City of Aurora Building Division
Project: **Monarchs Events**
Address: **16786 E Iliff Ave**
Occupancy Group: **A3**
Construction Type: **UBC VN**
RSN: **1899006**
Permit: **2025-2530957-LT**

City of Aurora Building Division
Reviewed for Code Compliance
Approved as Noted: **Kirk Nagle**
Date: **Jun 17, 2025**
2021 INTERNATIONAL CODES & 2023 NEC

PROJECT SCOPE OF WORK

THIS PROJECT AND THESE PLANS ARE INTENDED TO DESCRIBE A MODIFICATION TO EXISTING A-3 OCCUPANCY, TENANT IMPROVEMENT/ALTERATION TO A PORTION OF AN EXISTING COMMERCIAL MIXED USE BUILDING IN AURORA, COLORADO.

Title:
PROPOSED FLOOR PLAN

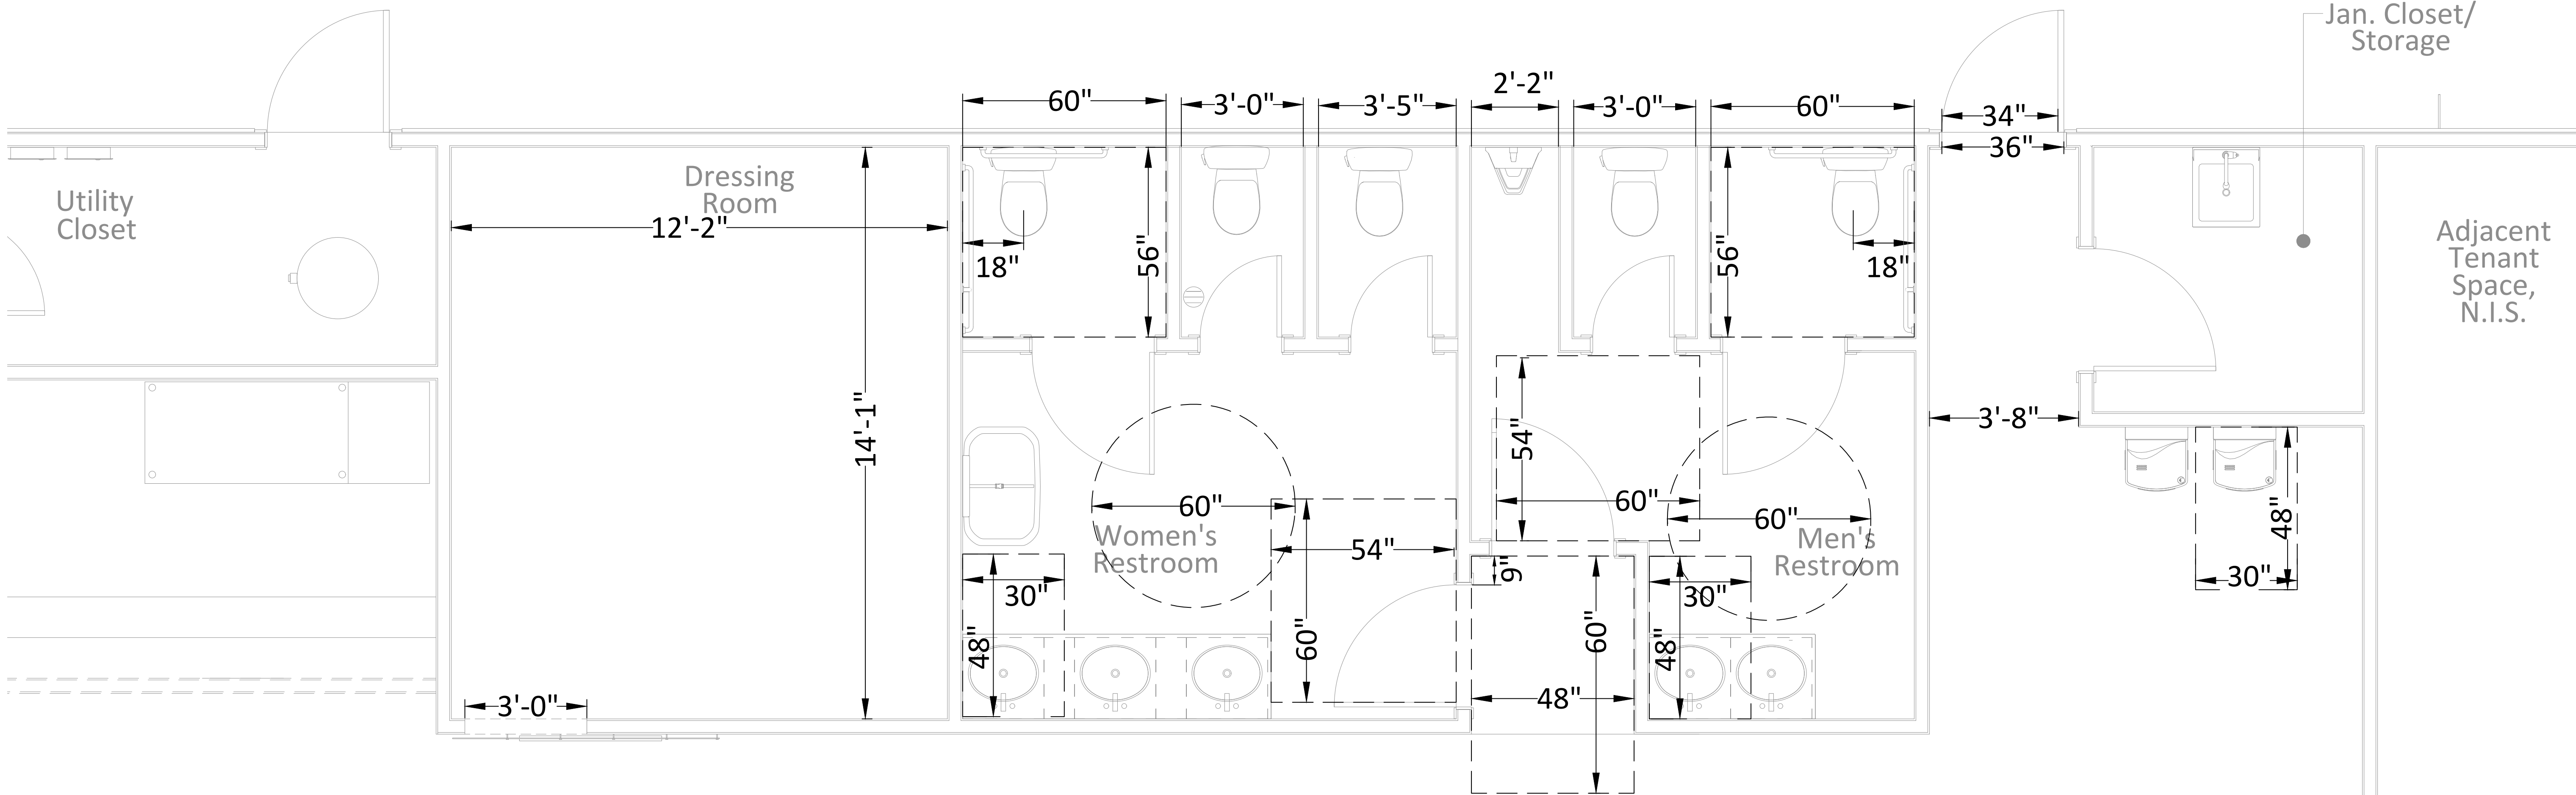
Provide Lever or other approved hardware.
On all new and relocated doors 2017 ANSI A117.1

PROVIDE A DIRECTIONAL SIGNAGE FOR
ROUTE TO REQUIRED PUBLIC TOILET
FACILITIES IBC 2902.4.1

Title:
ENLARGED FLOOR PLAN

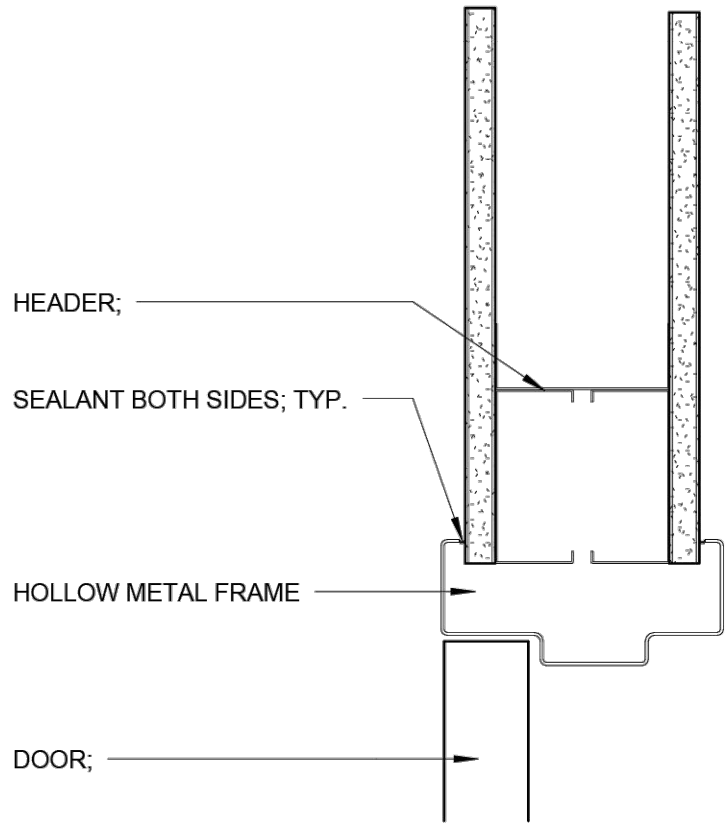
PROVIDE A DIRECTIONAL SIGNAGE FOR
ROUTE TO REQUIRED PUBLIC TOILET
FACILITIES IBC 2902.4.1

Design:	MLR
Review:	MLR
Date:	5-4-25
Scale:	1/4" = 1'-0"
REC Job No:	25004
Title: PLUMBING DETAILS SHEET	
Sheet No: P2

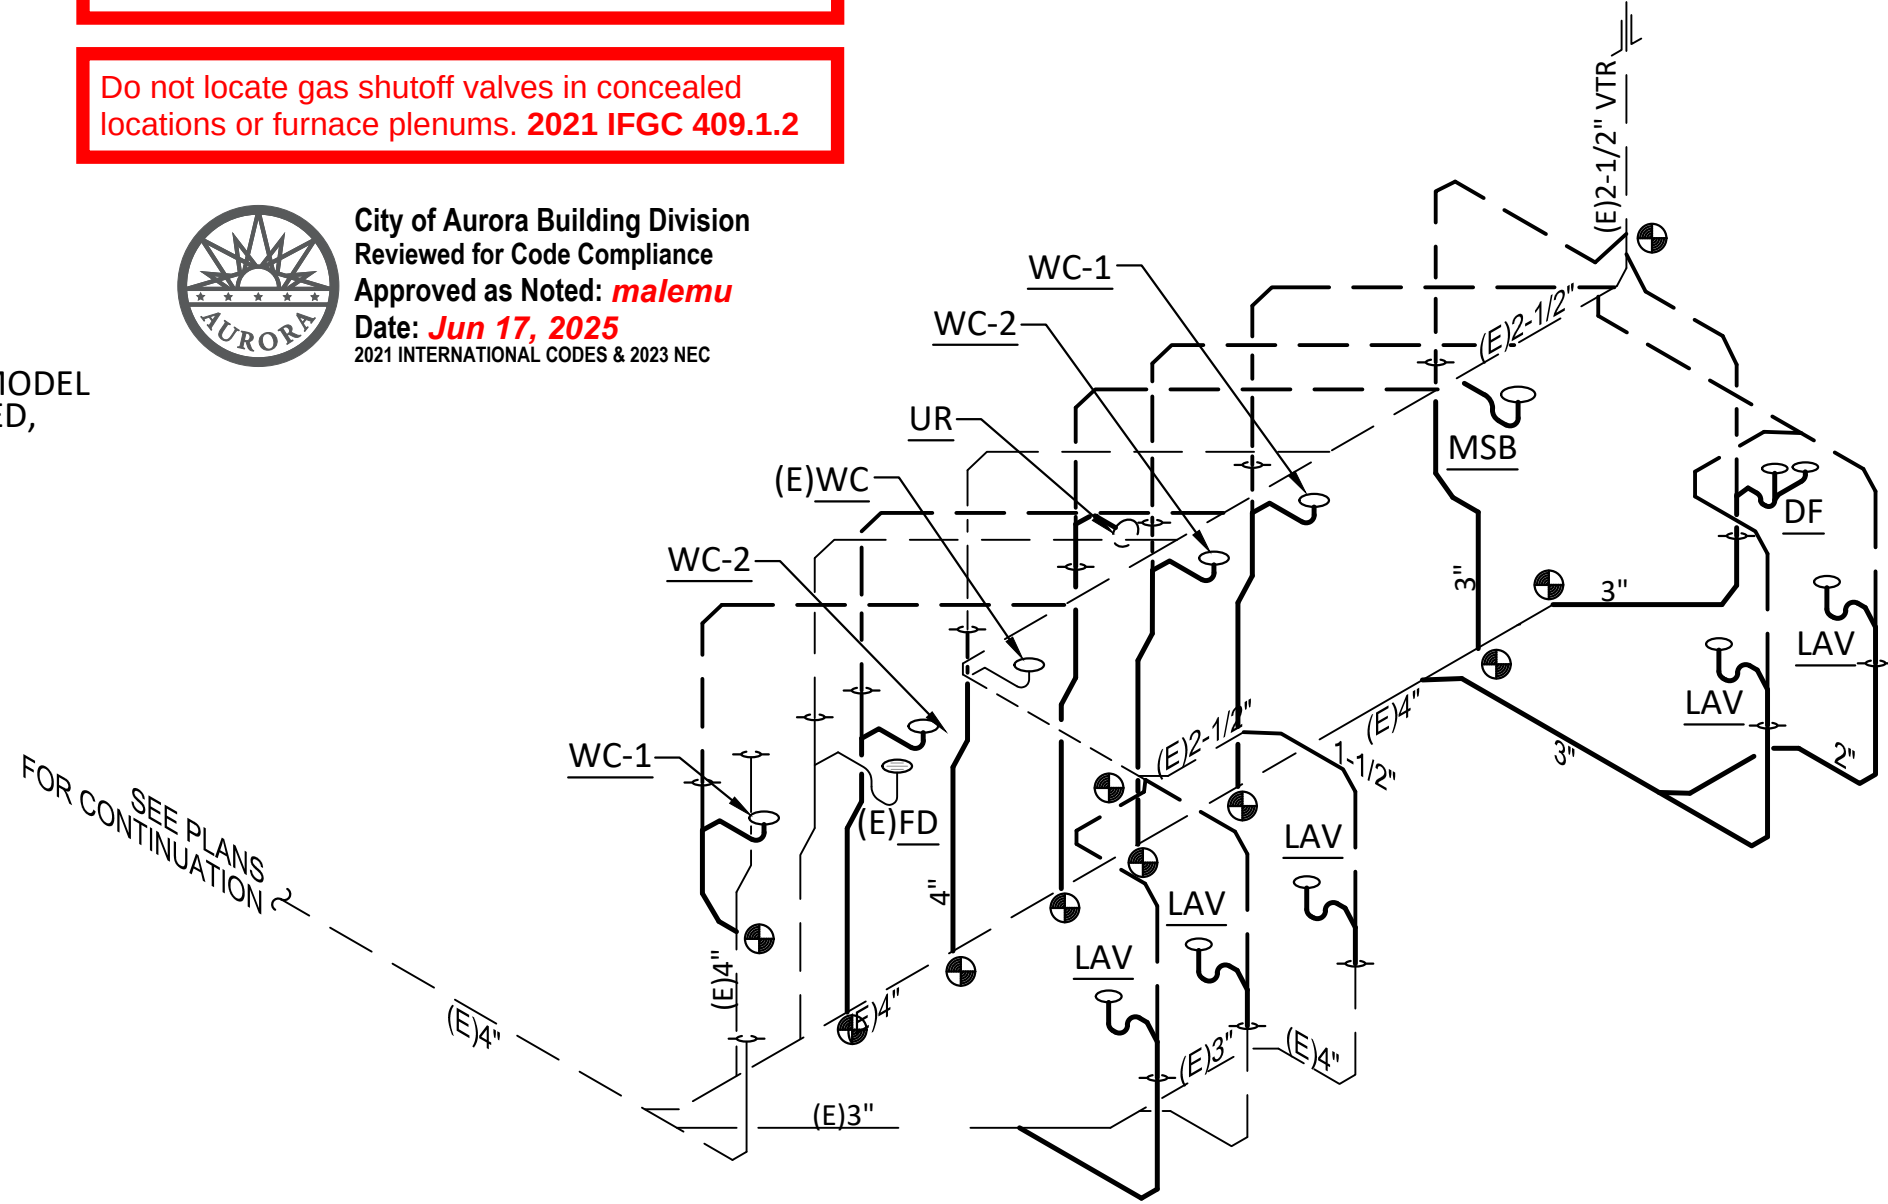
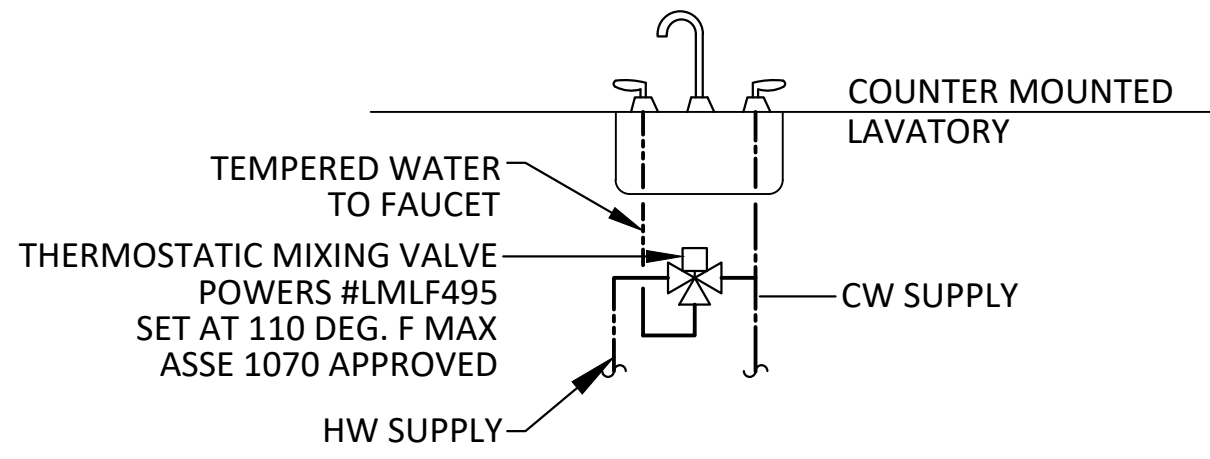
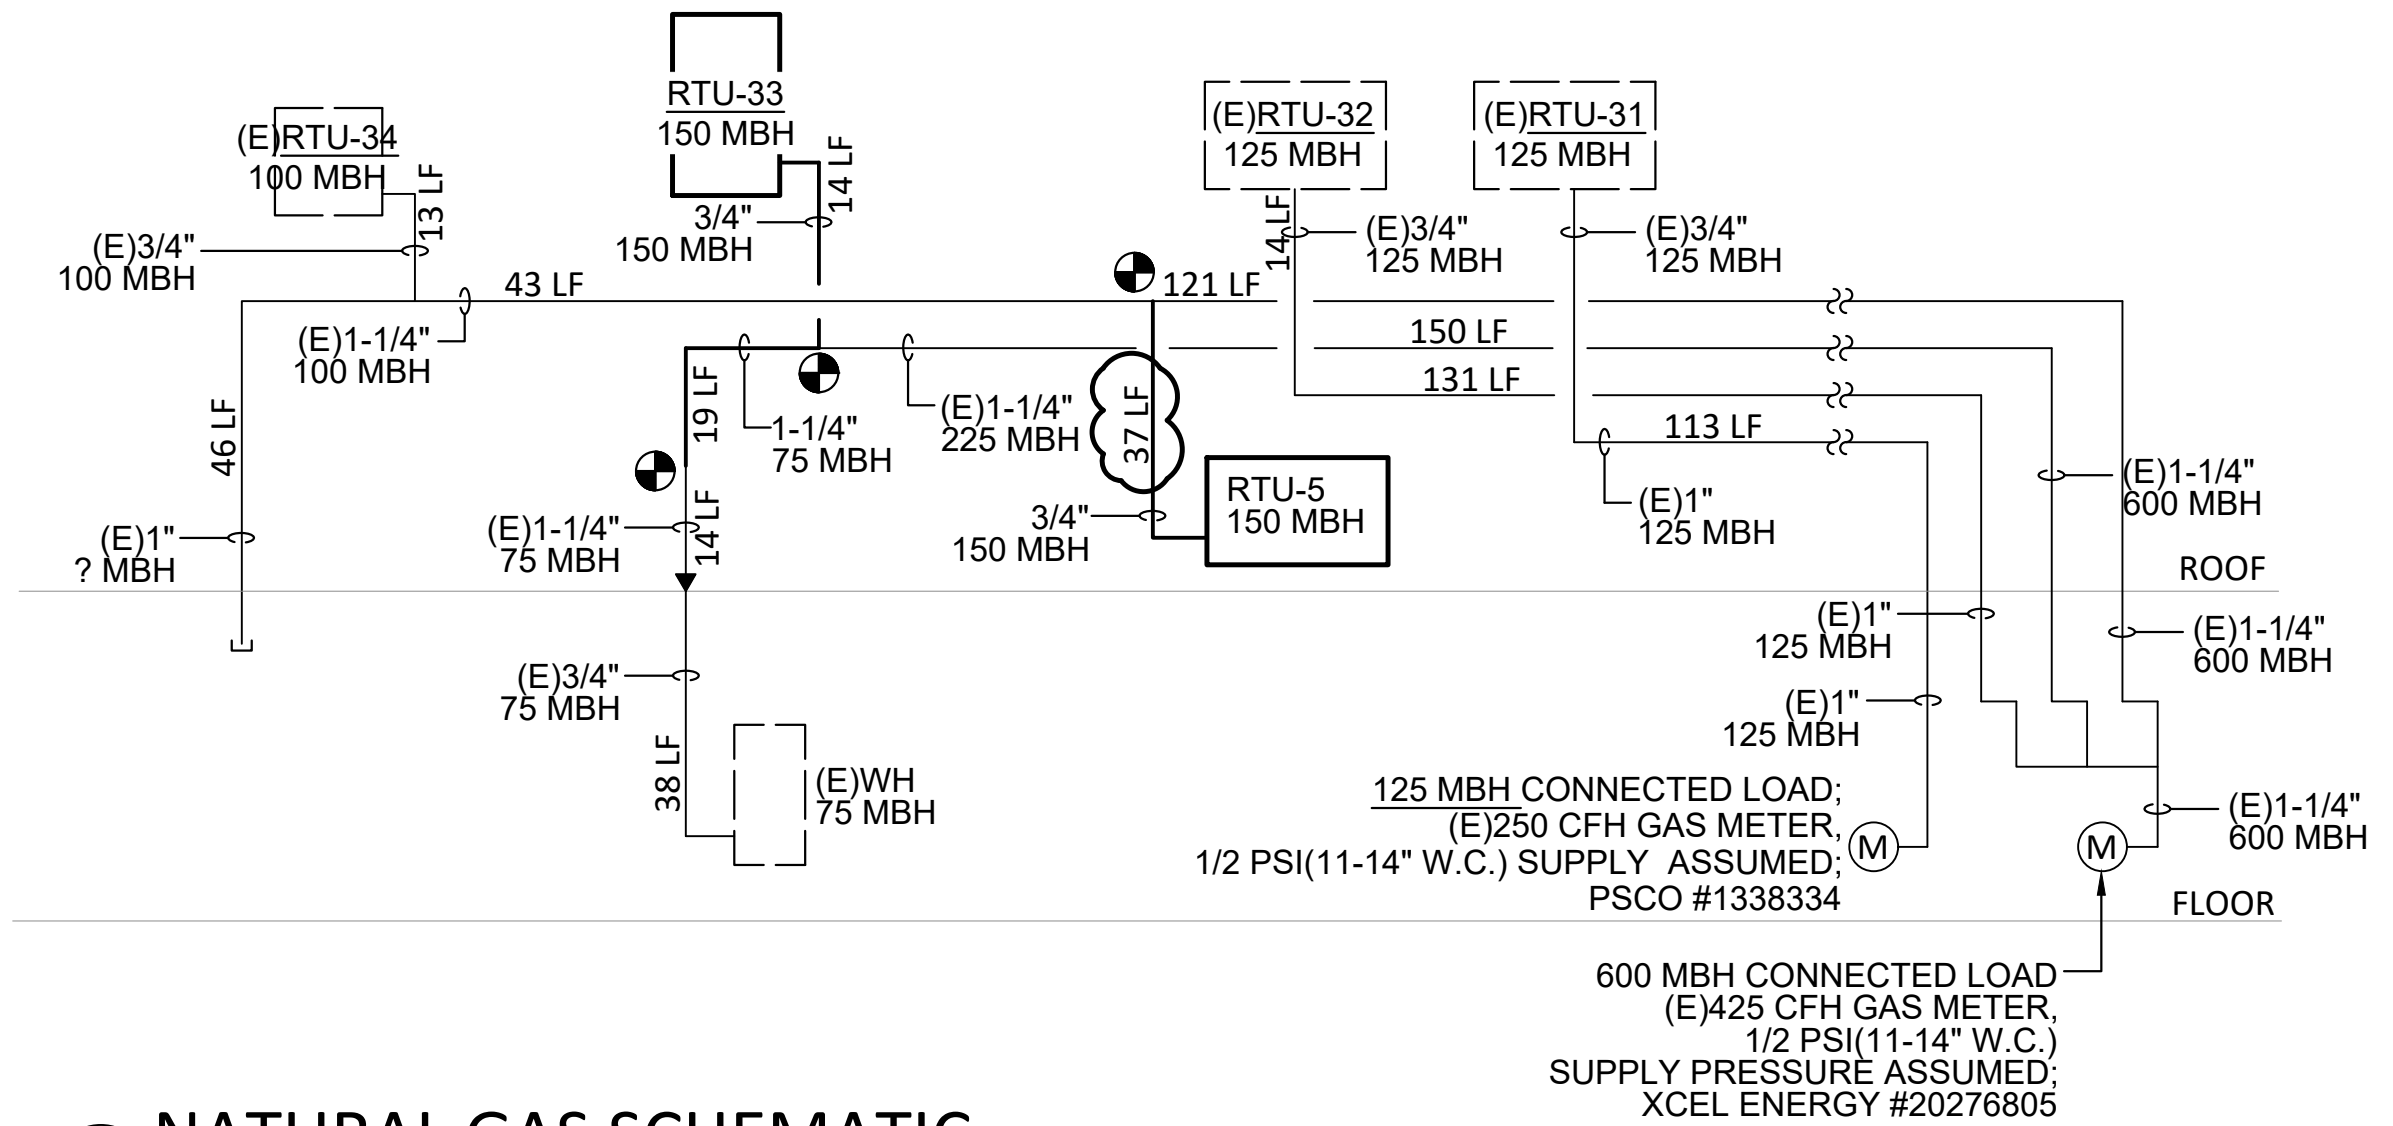
Provide for thermal expansion on hot-water supply system as required by 2021 IPC 607.3
